Amendments to the Drawings:

REMARKS/ARGUMENTS

An Office action was mailed January 10, 2006. In the Office action the drawings are objected to, the specification is objected to, and the claims are rejected either under 35 U.S.C. § 102 or 35 U.S.C. § 103. The Examiner is thanked for attention to the application.

Appl. No. 10/081,152 Amdt. Dated July 10, 2006 Reply to Office action of January 10, 2006 Annotated Sheet Showing Changes Sheet 2 of 7

Fig. 3

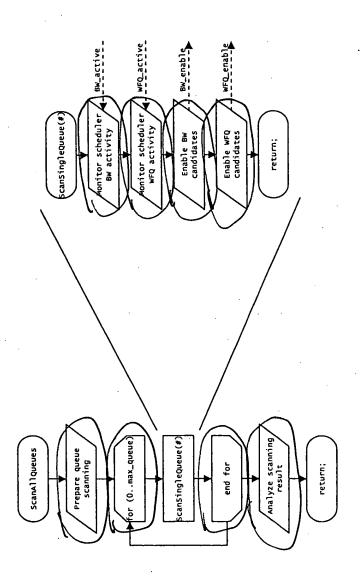
The attached sheet of drawings includes changes to all figures. The sheets, which include Figs. 1-8, replaces the original sheets including Figs. 1-8.
